**STATE OF TENNESSEE
DEPARTMENT OF TRANSPORTATION**

INSTRUCTIONAL BULLETIN NO. 21-20

Regarding Various Revised, New and Voided Standard Drawings

Effective May 13, 2022 letting (March 2, 2022 Turn-in), the following Standard Drawings have been revised or are new. In addition, the Roadway Design Guidelines Chapter 7 – Item Numbers, Sections 7-611.00, Manholes, Catchbasins, Inlets and Pipe End Walls, and Section 7-705.00, Guardrails, of the Roadway Design Guidelines has been modified to reflect any changes to or new item numbers in the Standard Drawings of this Instructional Bulletin.

STATE OF TENNESSEE
 STANDARD DRAWING
DEPARTMENT OF TRANSPORTATION
TYPE 12 GUARDRAIL TERMINAL BURIED-IN-BACKSLOPE

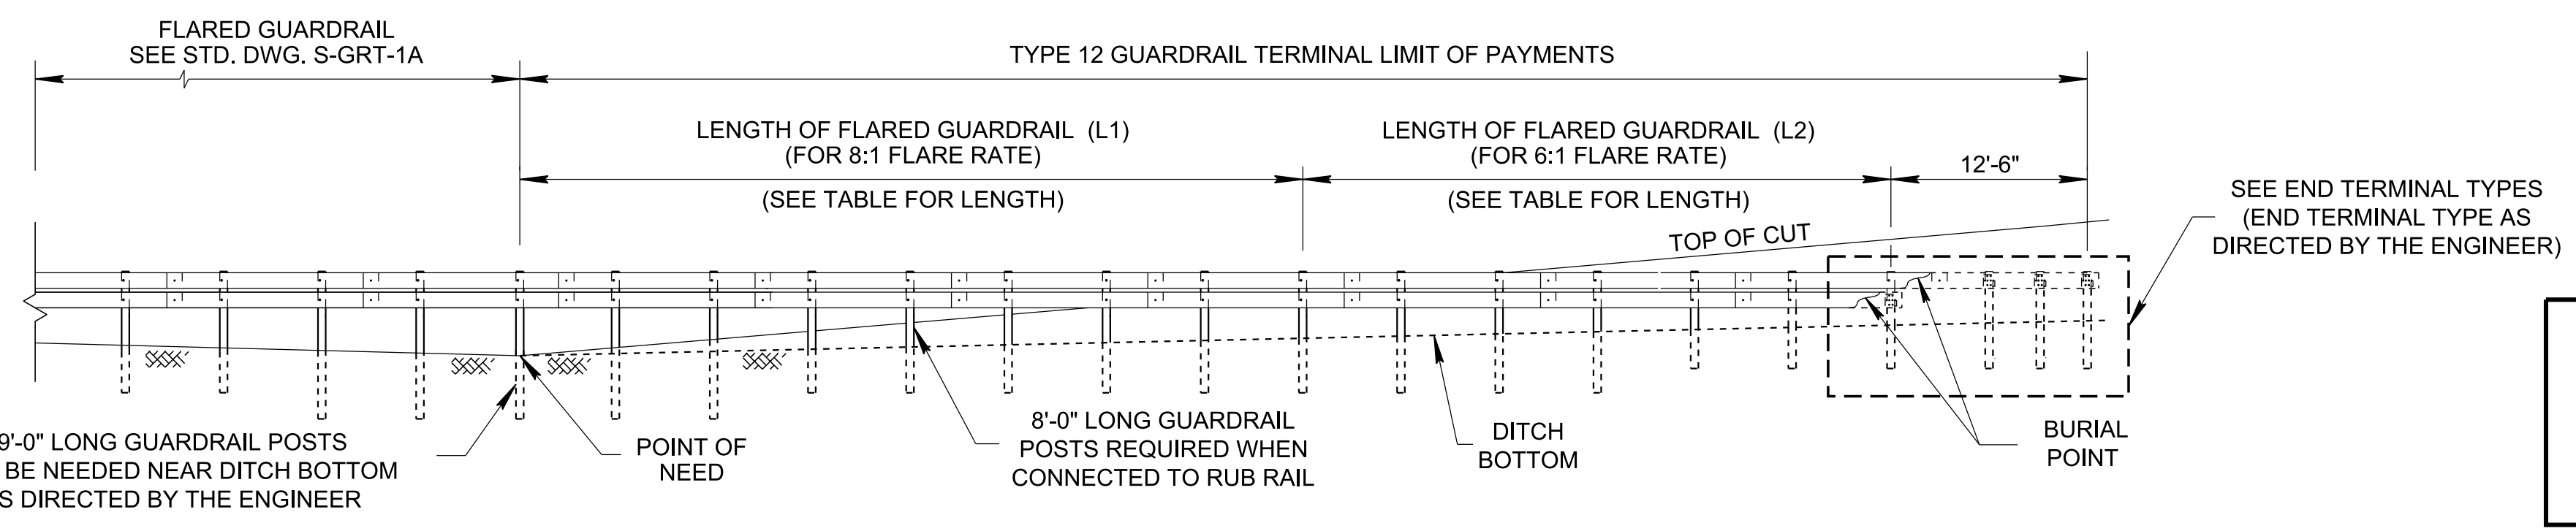
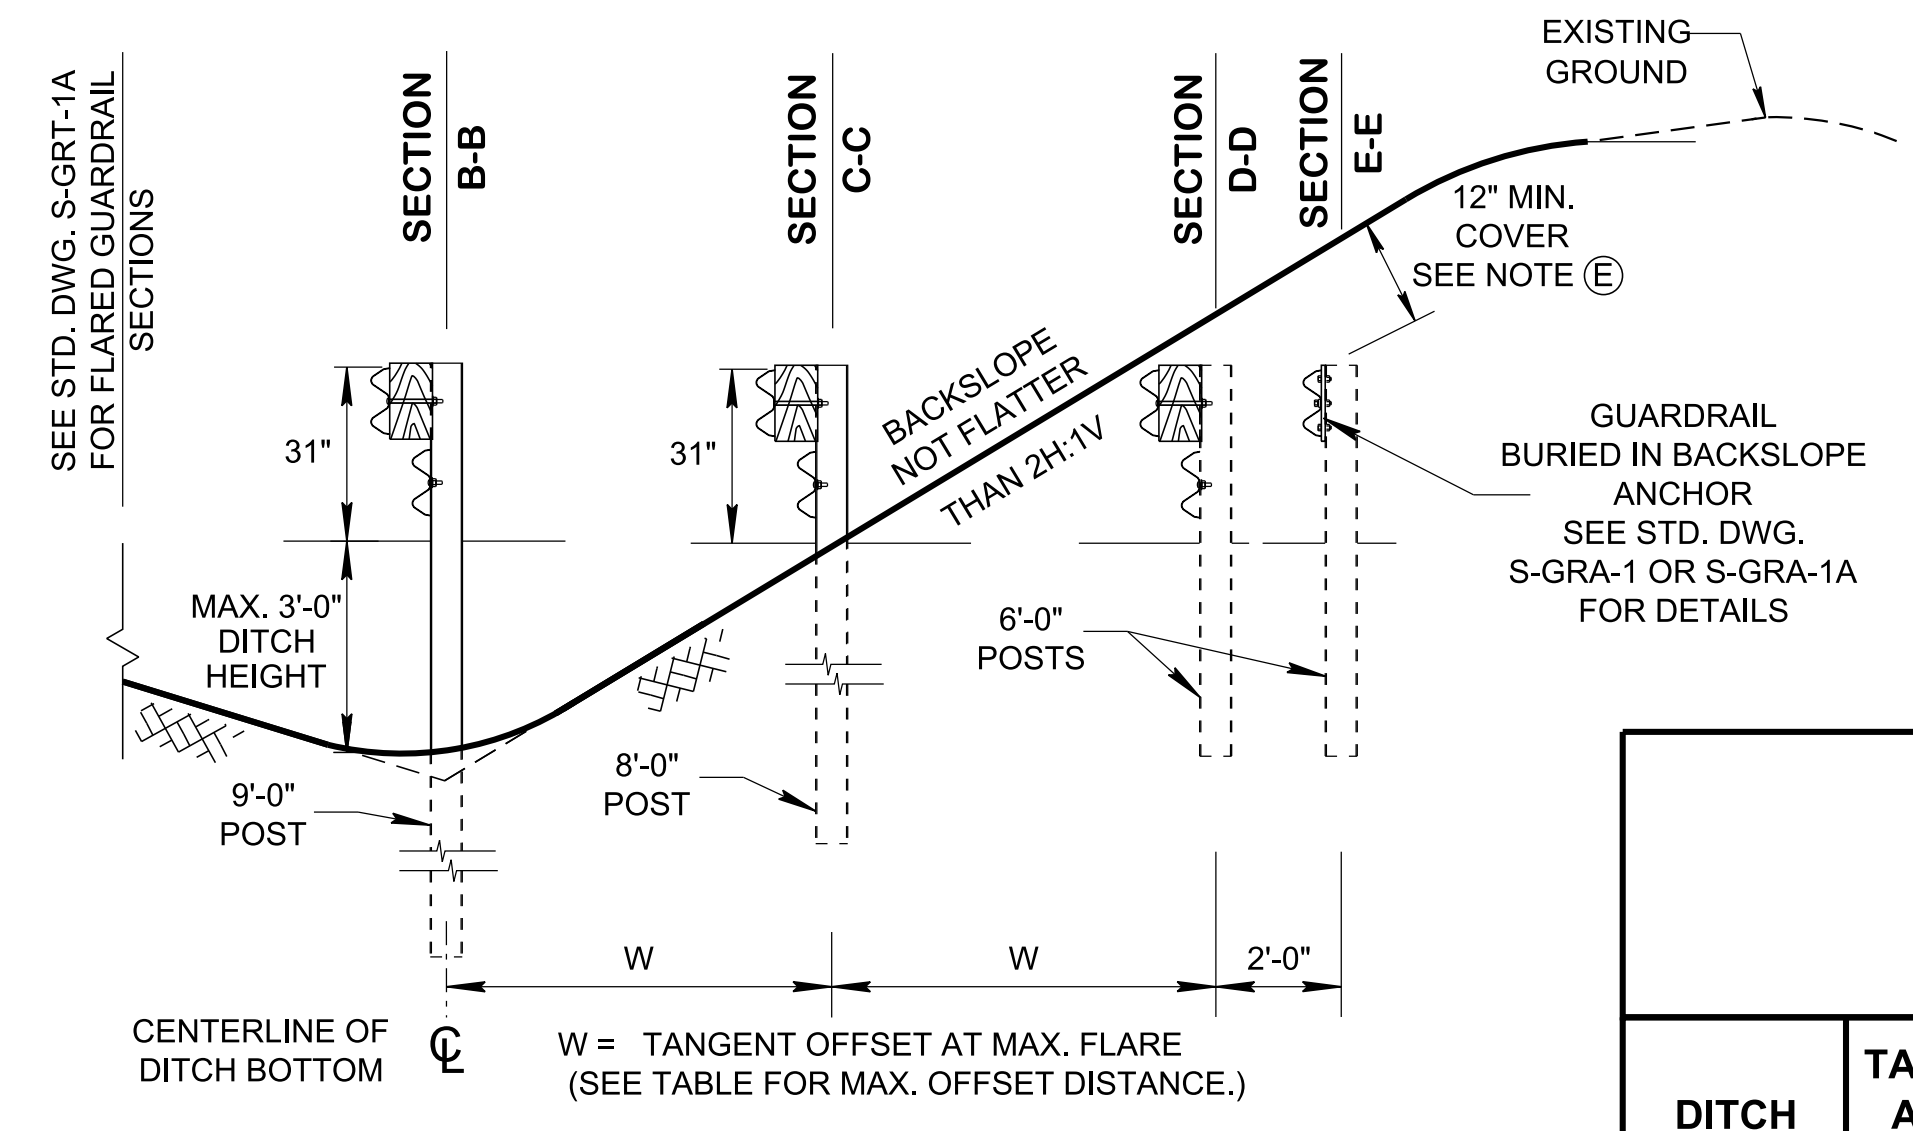
REV. 10-29-2021: THE PLAN AND THE ELEVATION VIEWS WERE REDRAWN. THE PERSPECTIVE VIEW AND THE FLARE RATE TABLE WERE REMOVED. SECTIONS WERE MERGED AND REDRAWN. THE NEW TABLE AND THE END TERMINAL TYPES DETAIL WERE ADDED. ADDED NEW NOTE TO DESIGNER NOTE AND REMOVED FROM GENERAL NOTE. REARRANGED GENERAL NOTE NO'S AND ADDED GENERAL NOTE (L) REVISED GENERAL NOTES (I) AND (K)

32" HEIGHT WALL

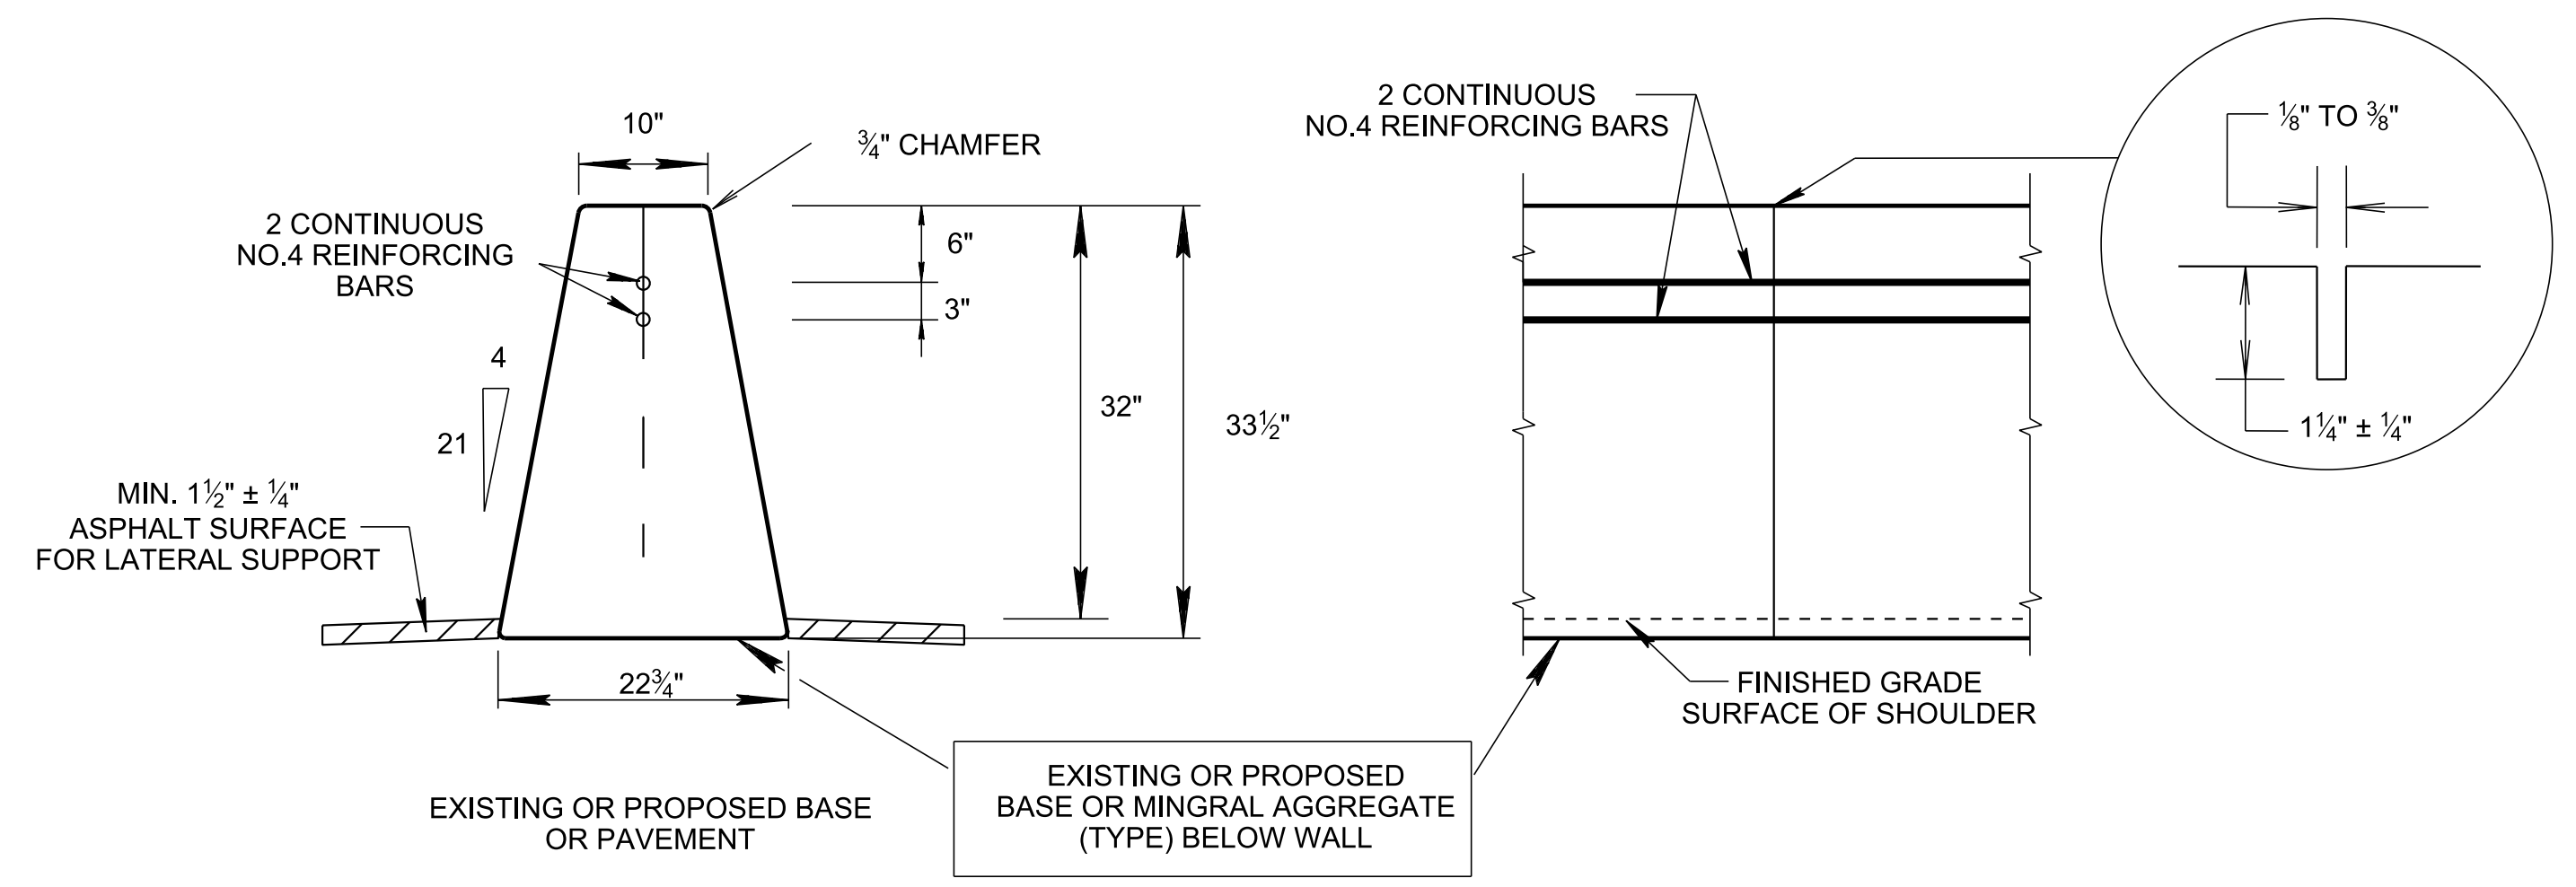
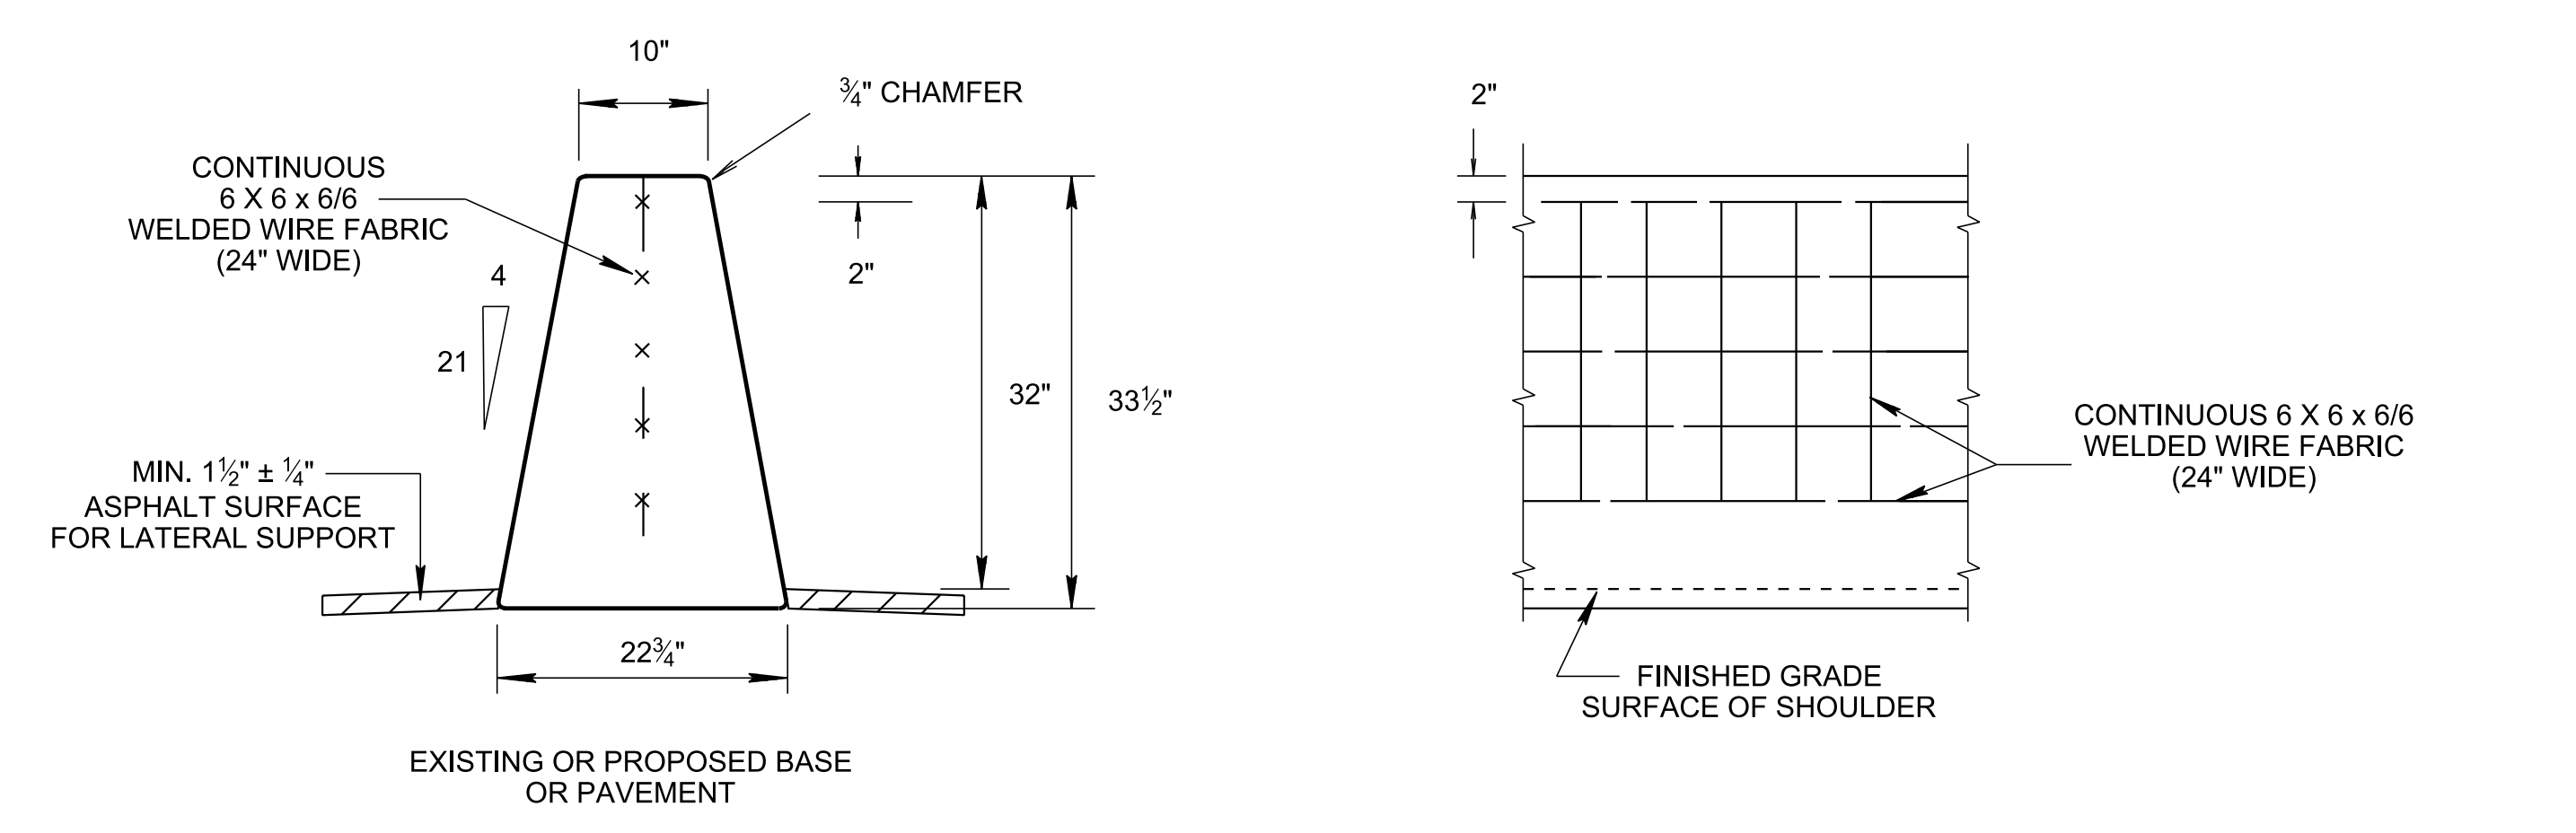
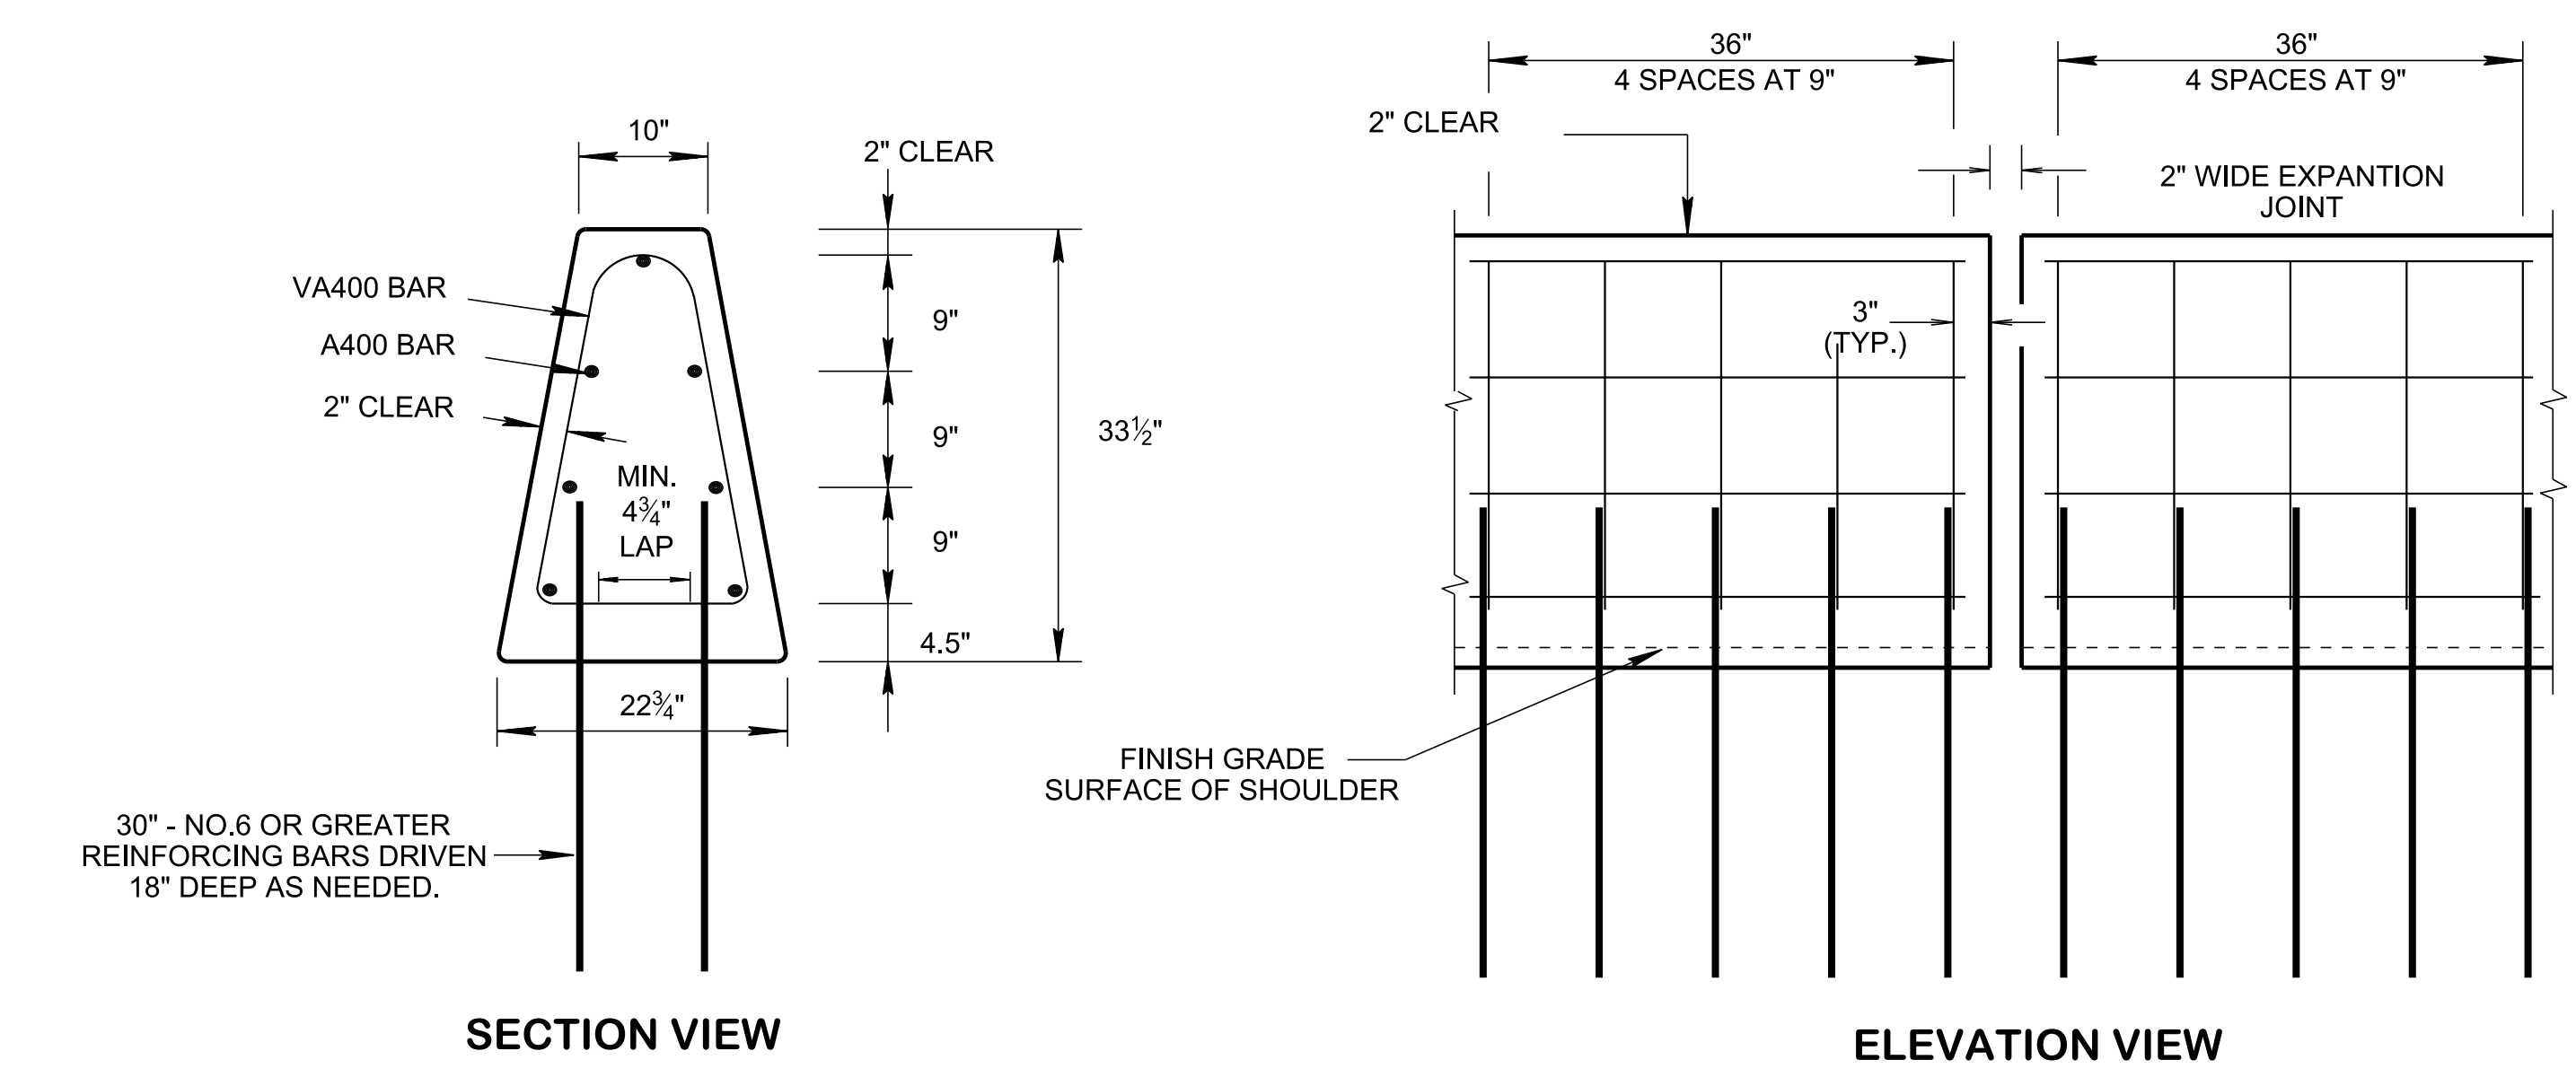
REV. 8-19-13: REVISED ITEM NUMBER DESCRIPTION.
 REV. 05-01-20: ADDED NOTE TO DESIGNER. REDREW SHEET.
 REV. 07-17-20: REVISED NOTE TO DESIGNER.
 REV. 10-29-2021: DELINEATOR MOUNTING DETAIL AND DELINEATOR NOTES WERE REMOVED. ADDED GENERAL NOTE (K) FOR DELINEATOR MOUNTING DETAILS REFERENCE STD. DWG. AND PLAN VIEW.

(K) REFER TO STANDARD DRAWING T-M-18A FOR MEDIAN BARRIER DELINEATOR MOUNTING DETAILS AND NOTES. THE COST OF FURNISHING AND INSTALLING MEDIAN BARRIER DELINEATORS SHALL BE INCLUDED WITH THE BID PRICE FOR CONCRETE MEDIAN BARRIERS.
